TECHNICAL COMMITTEE RECOMMENDATION

TECHNICAL COMMITTEE: Signals Technical Committee

TOPIC: **Proposed new Chapter 4M Traffic Control Beacons For Pedestrians**

Figure 4M-1. Guidelines for the Installation of Pedestrian Beacons on Low Speed Roadways

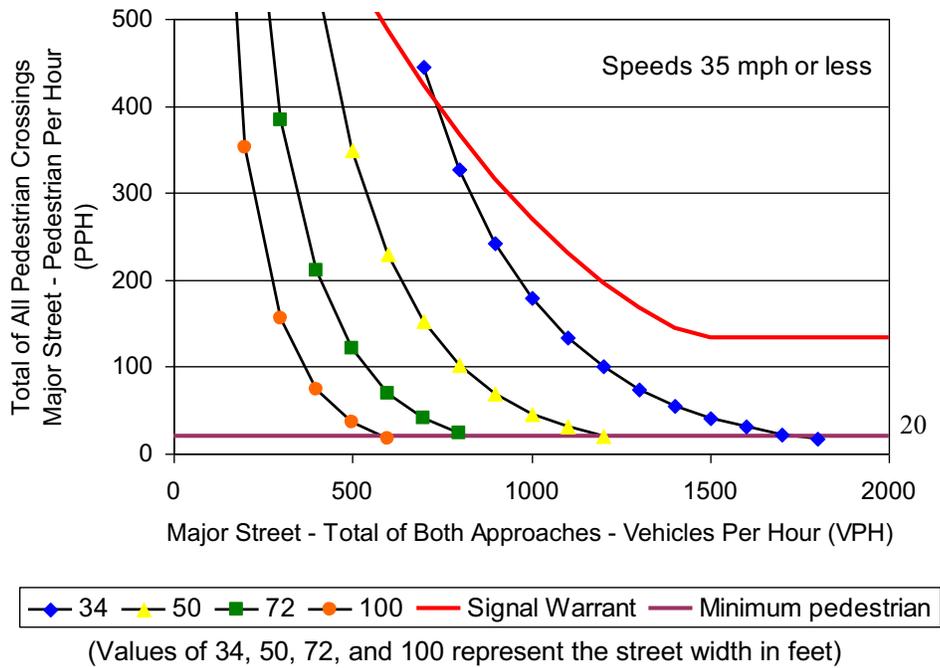
- Deleted the limitation on installation only at midblock locations. Installation now permitted at midblock or intersection locations.
- Added Guidance, including figures, to show recommended pedestrian and vehicle volumes for various street widths for installation consideration. These guidance figures were developed based on the TCRP/NCHRP D-08/3-71 research. The curves were developed using the pedestrian delay equation included in the *Highway Capacity Manual* and were calculated using 16 pedestrian-hours of delay in the peak hour for the highest approach (or 21.3 pedestrian-hour of delay for both approaches). Guidelines on selecting pedestrian treatments were developed as part of the TCRP/NCHRP research and are documented in TCRP Report

112/NCHRP report 562. The curves included in Figures 4M-1 and 4M-2 reflect the guideline recommendations on when a “red” device should be considered.

For a major street where the posted or statutory speed limit or the 85th-percentile speed is 60 km/h or less or is 35 mph or less, the need for a pedestrian beacon should be considered if the engineering study finds that the plotted point representing the vehicles per hour on the major street (total of both approaches) and the corresponding total of all pedestrians crossing the major street for 1 hour (any four consecutive 15-minute periods) of an average day falls above the applicable curve in Figure 4M-1 for the length of the crosswalk (measured in feet).

Figure 4M-2. Guidelines for the Installation of Pedestrian Beacons On High Speed Roadways

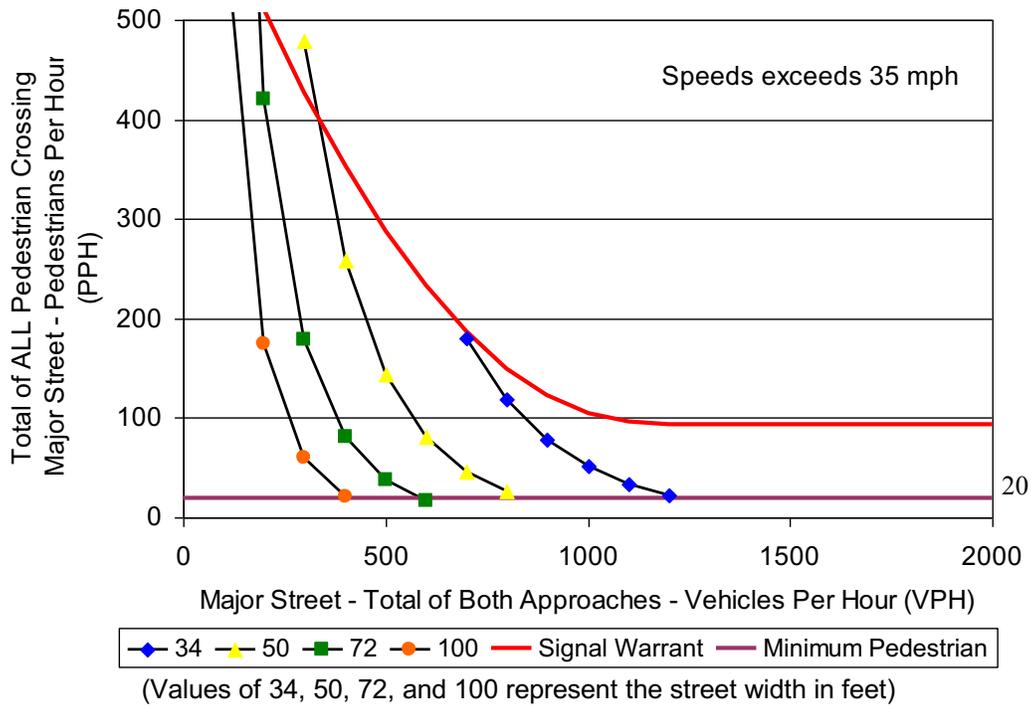
[Note: Metric versions of Figures 4M-1 and 4M-2 also need to be developed.]

For a major street where the posted or statutory speed limit or the 85th-percentile speed exceeds 60 km/h or exceeds 35 mph, the need for a pedestrian beacon should be considered if the engineering study finds that the plotted point representing the vehicles per hour on the major street (total of both approaches) and the corresponding total of all pedestrians crossing the major street for 1 hour (any four consecutive 15-minute periods) of an average day falls above the applicable curve in Figure 4M-2 for the length of the crosswalk (measured in feet).

Figure 4M-3. Example of Sequence for a Pedestrian Beacon

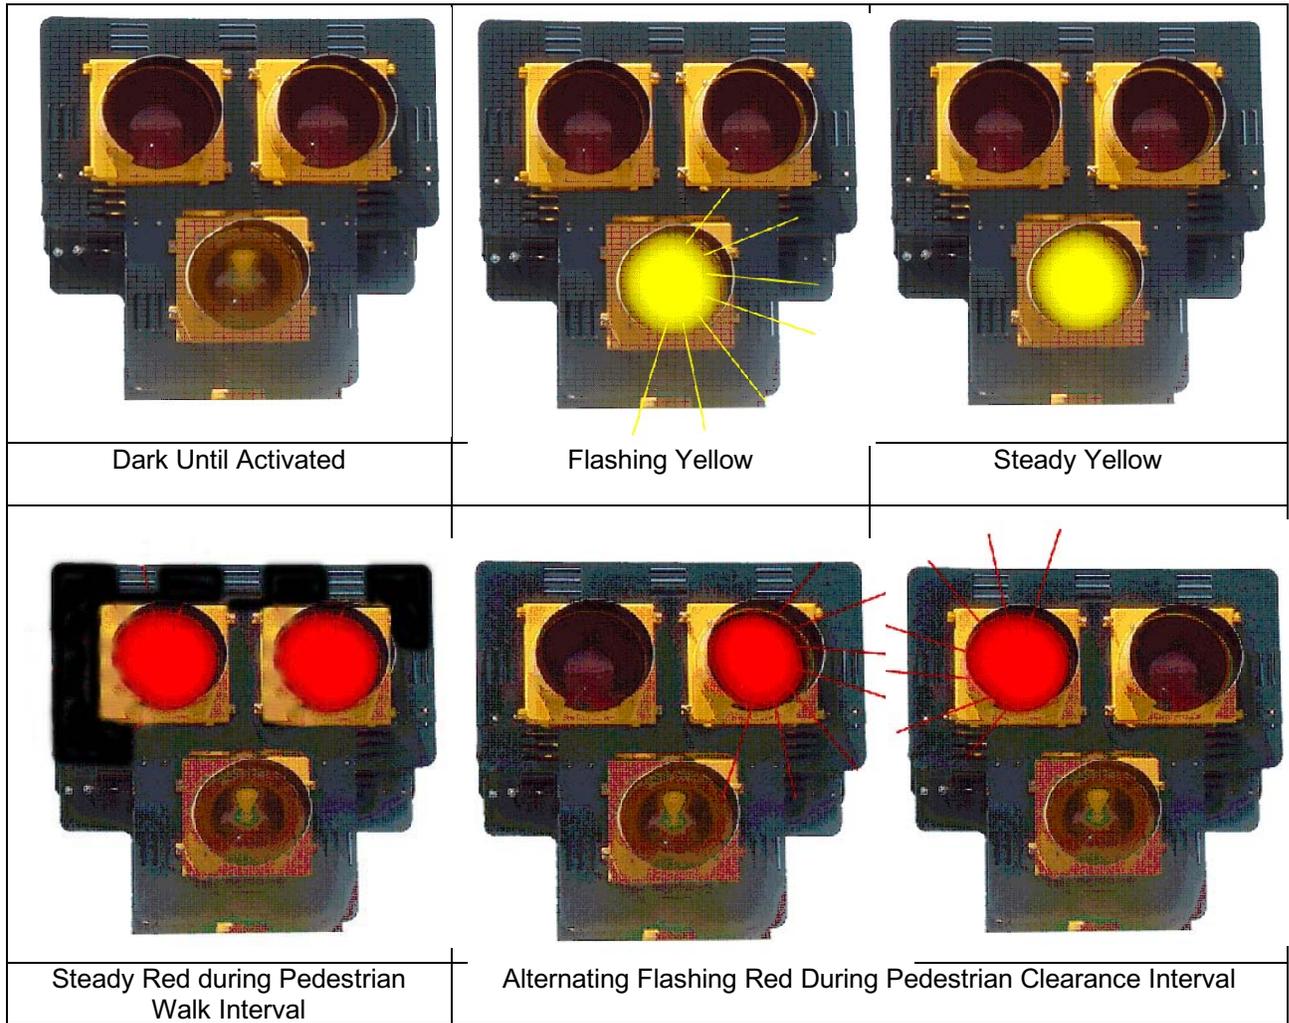
- Made minor wording clarifications concerning installation consideration and compliance with other sections of the MUTCD.
- Added a standard that traffic approaching the location on any minor streets or driveways be controlled by STOP signs.
- Modified a Standard to note that the steady don't walk indication shall be displayed when the vehicle indications are dark.

A pedestrian beacon shall consist of three signal sections, with a CIRCULAR YELLOW signal lens centered below two horizontally aligned CIRCULAR RED signal lenses (see Figure 4M-3).

Upon actuation by a pedestrian, a pedestrian beacon shall display a flashing CIRCULAR YELLOW signal indication, followed by a steady CIRCULAR YELLOW signal indication, followed by both steady CIRCULAR RED signal indications during the pedestrian walk interval, followed by alternating flashing CIRCULAR RED signal indications during the pedestrian clearance interval (see Figure 4M-3). Upon termination of the pedestrian clearance interval, the pedestrian beacon shall revert to a non-illuminated condition.

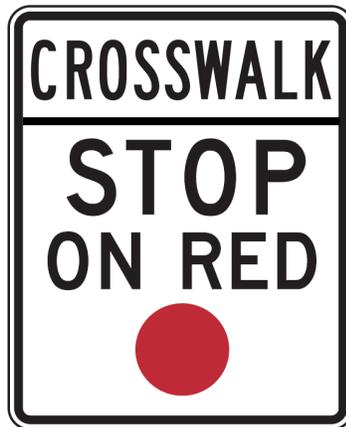
The new pedestrian beacon section recommended by the Signals Technical Committee includes a requirement that a CROSSWALK STOP ON RED sign be installed. This is a new sign. The Signal Technical Committee recommends that the following new sign and associated text be added in Part 2. The Regulatory and Warning Signs Technical Committee reviewed a version of this sign at the June 2006 meeting and indicated its support. The sign was modified slightly at the January 2007 meeting.

- The new sign is proposed to be numbered R10-23.
- The following paragraph is proposed to be added as a Standard just prior to the last paragraph of Section 2B.45:

- The following sign image is proposed to be added to Figure 2B-19:

The CROSSWALK STOP ON RED (symbolic red ball) (R10-23) sign (see Figure 2B-19) shall be used in conjunction with pedestrian beacons (see Chapter 4M).
